EPSON PRODUCT SUPPORT BULLETIN

Date: 04/20/2009
PSB #: PSB.2009.06.001
Reference: TI 09-05e Rev. A/B
Product(s): PowerLite 735c / Cinema 500 / 737c / 745c / 755c / 765c / 830p / 835p / 1705c / 1715c / 6100i / 6110i / 7800p / 7850p / 7900NL / 8300i / 8300i with EasyMP.net module / 9300NL / 1815p / 1825 / 822p / 83c / 822+ / 83+ / G5000 / Pro G5150 / Pro G5350 / Pro G5200W / 1725 / 1735W / 400W / 410W / 84 / 85 / 825 / 826W
PowerLite 61p / 81p / 82c / 821p / 1810 / 260d (Latin America) / 280d (Latin America) with TCP/IP to Serial converter
Subject: Release of EMP Monitor for Windows version 4.30

EMP Monitor V4.30

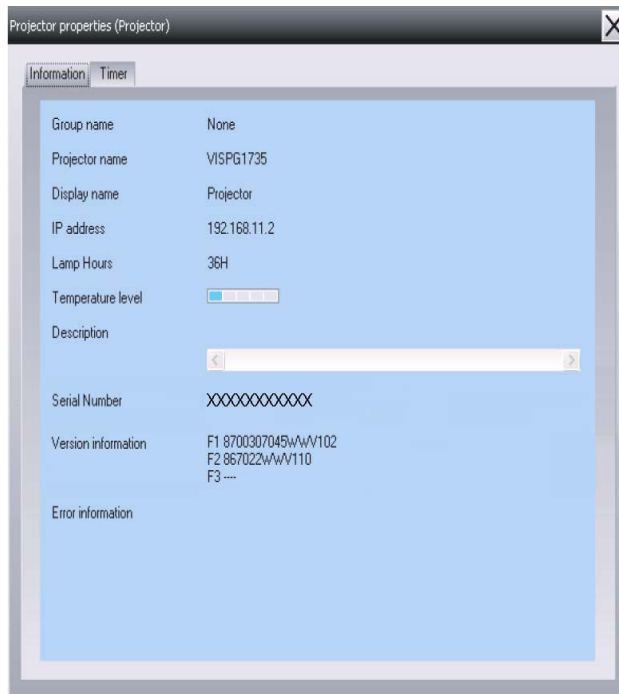
(2) Addition of Input Source (Only PowerLite 84 / 85 / 825 / 826W)
Previous version of EMP Monitor included USB Display, USB and LAN as one source: EasyMP.

The input source buttons for USB display, USB, and LAN are available as separate input sources as shown below:
